CITY OF OAKLAND

Memorandum

Re: Design Review Follow-up for PLN20092 415 20th St. Hines Development

The Design Review Committee (DRC) reviewed a proposal for a new 622-foot tall office tower at 415-20th St. on January 27th, 2021. The applicant has submitted revised plans addressing the DRC's comments (**Exhibit A**). The original staff report addressing the project is attached as **Exhibit B**.

PLAZA ACTIVATION AND OPERATION

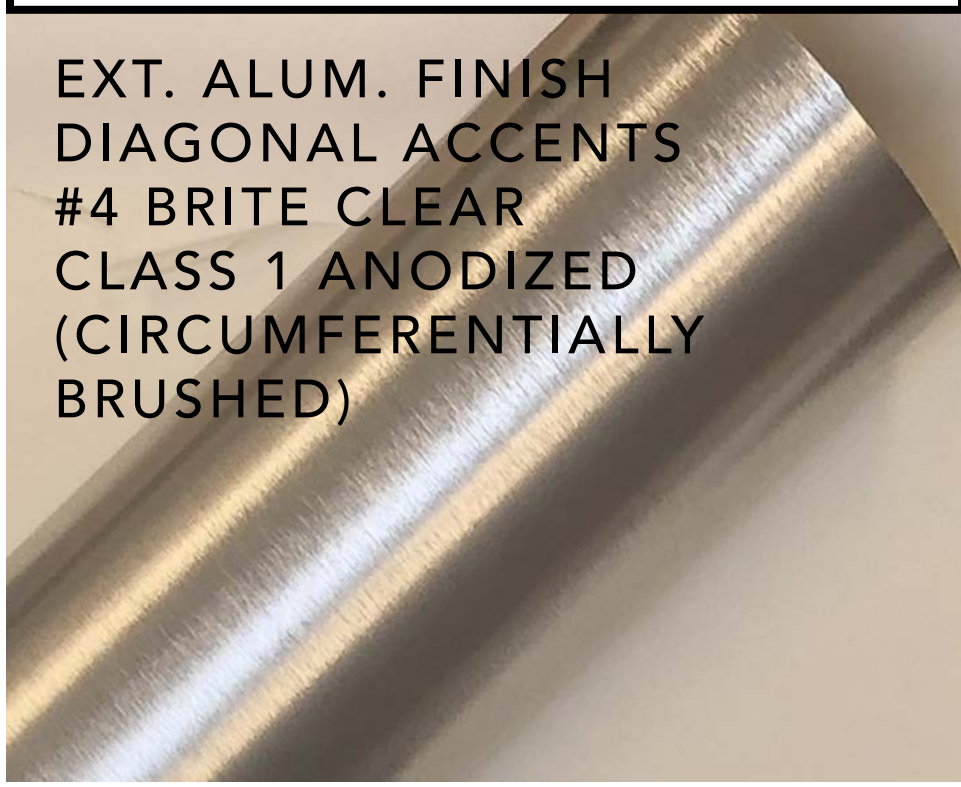
- Ensure the execution of the ground floor plaza is well thought out to create an activated space
- Provide physical material mock-up prior to construction and coordinate with staff to provide more details on materials to DRC and PC
- Clarify approach to parking (private parking only?)
- Provide renderings of views from key vantage points, including from Lake Merritt and the skyline coming off of the Bay Bridge
- Provide alternatives for top of building from a design perspective and address any potential bird issues with lights or open area
- Add artistic elements on parking podium to add visual interest

- A statement addressing Plaza activation and operation is added, focusing on safety, programming and maintenance.
- The applicant modified the building crown and observation deck by changing the color of the vertical and diagonal accents from silver to white and extending the color on the vertical columns down the façade for approximately two floors. This treatment highlights the top element. Lighting is also enhanced.
- An additional detail sheet addressing building materials is provided.
- Tower visibility studies are provided from seven viewpoints along I-80 eastbound, I-80 and I580 interchange, I090 near the 14th St and 18th St exit and views from the east and south shores of Lake Merritt.

- 24/7 SECURITY TO KEEP THE AREA SAFE AND CONSTANTLY MONITORED
- MANNED BICYCLE PARKING FOR SAFETY AND SECURITY
- PORTERS TO KEEP THE PLAZA CONTINUOUSLY CLEAN AND ORGANIZED
- RETAIL CARTS (FLOWER CARTS, OTHER F&B OFFERINGS) TO PROMOTE ACTIVITY WITHIN SPACE
- PLAZA PROGRAMMING (MUSIC, ART EXHIBITS, ETC)
- FURNITURE THAT IS BOTH RESILIENT AND INVITING FOR PUBLIC CONGREGATION
- PUBLIC WIFI TO ENCOURAGE PLAZA ACTIVATION
- MONITOR WIND IMPACT AND MITIGATE AS NEEDED FOR COMFORTABLE USE
- MONITOR TEMPERATURE AND ADD OUTDOOR HEATING UNITS AS NEEDED

TOWER VISIBILITY STUDIES - VIEWPOINTS

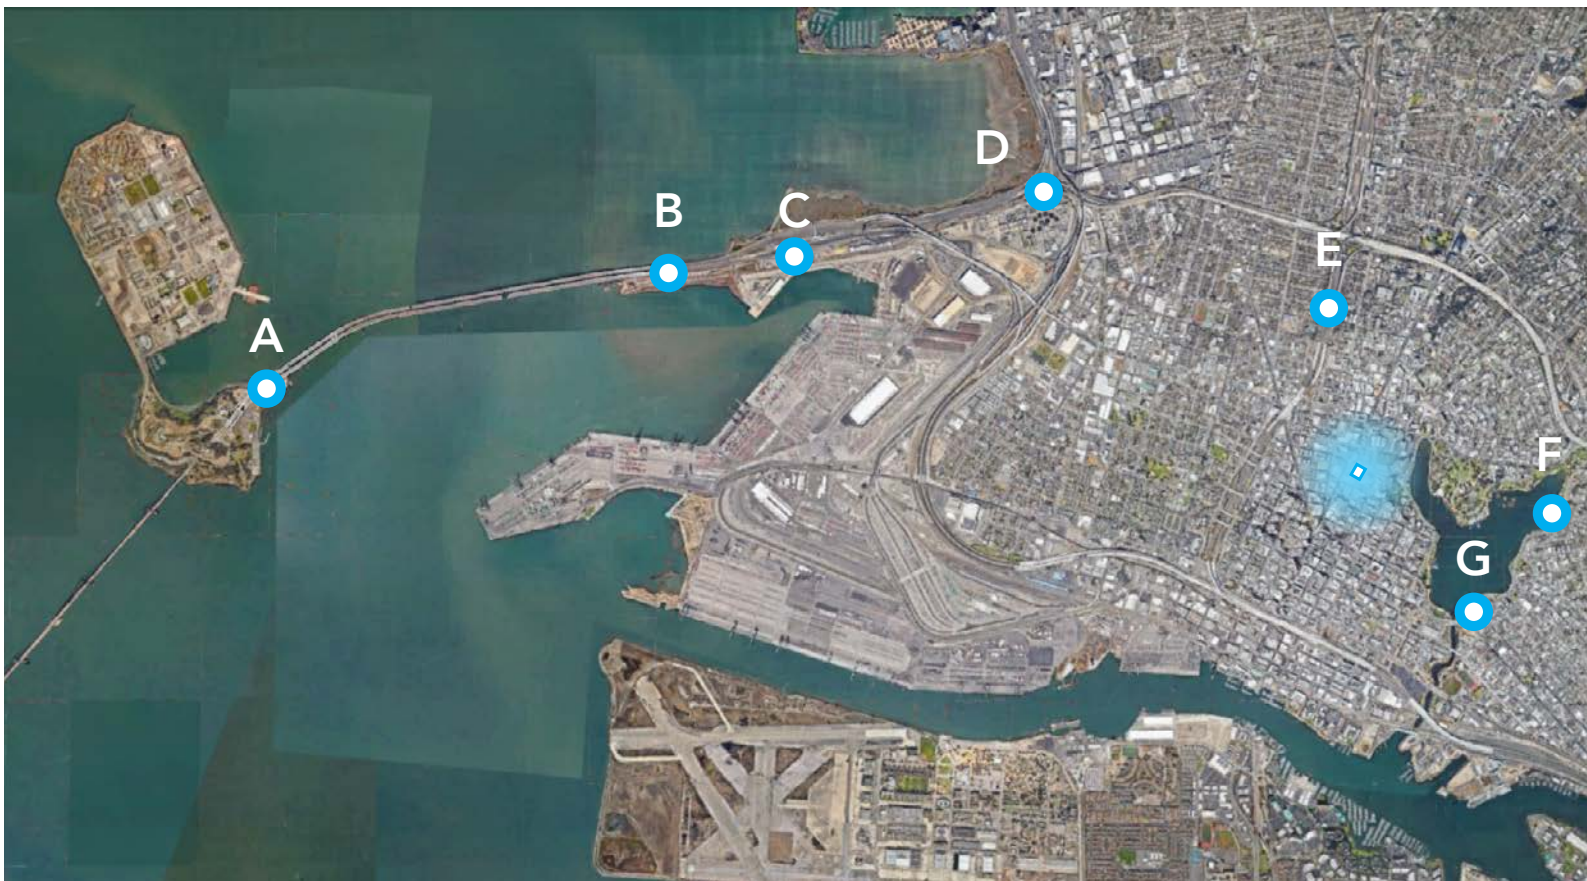
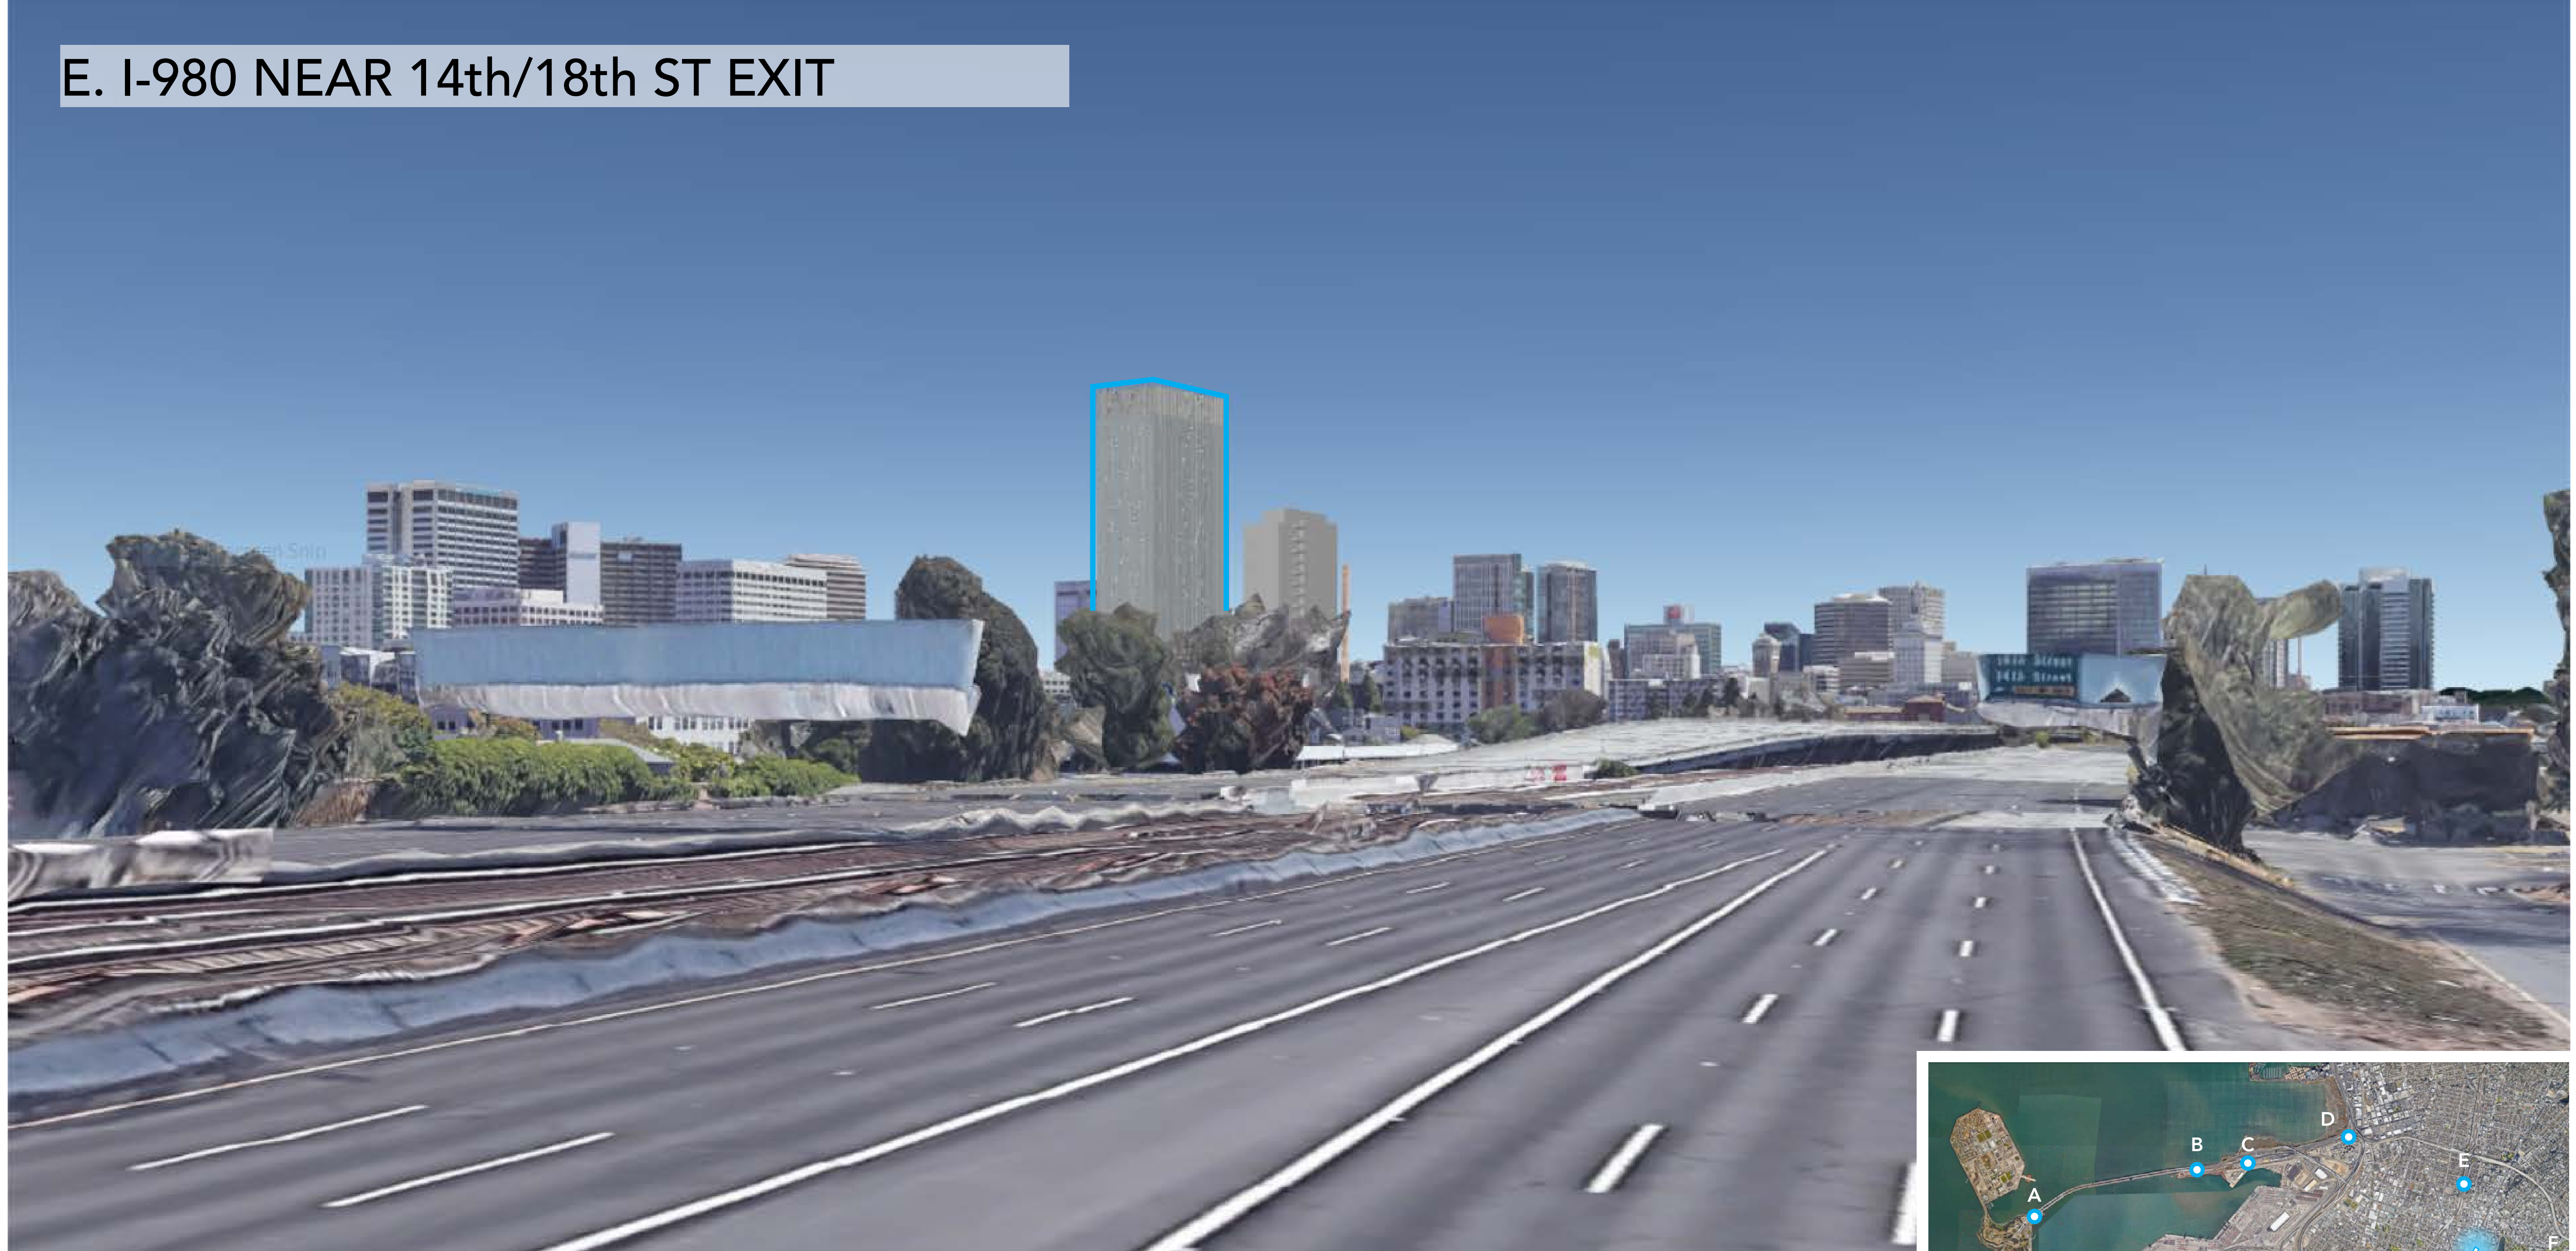
The DRC directed the applicant to return to DRC to present the key view points, the alternatives for the top of the building, and the art on the parking podium.

PODIUM PLAN

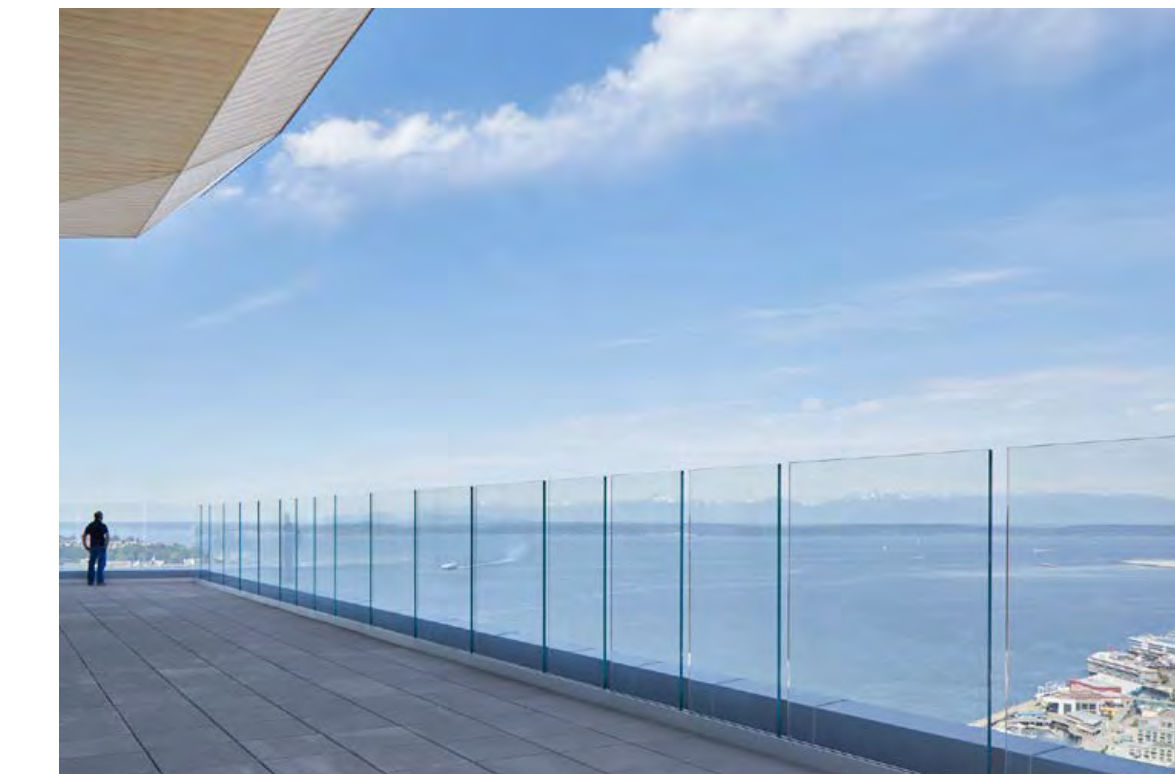
- The plan set includes a 10' high glass windscreen on the podium deck to reduce wind effects to the surrounding area. The screen would be installed in the interior of the project on the podium deck, but would be visible from 20th St. An elevation of the wind screen is shown on the Podium plan drawing and a plan view is shown on the Grading Elevation, P. 27. Does the DRC find the windscreen design to be consistent with the overall building design?

GLASS WINDSCREEN TO BE ADDED AT LOCATION INDICATED ON PLAN. SCREEN TO BE COMPRISED OF GLASS PANELS APPROXIMATELY 10' TALL WITH CODE COMPLIANT GAPS IN BETWEEN. SEE PRECEDENT IMAGES BELOW.
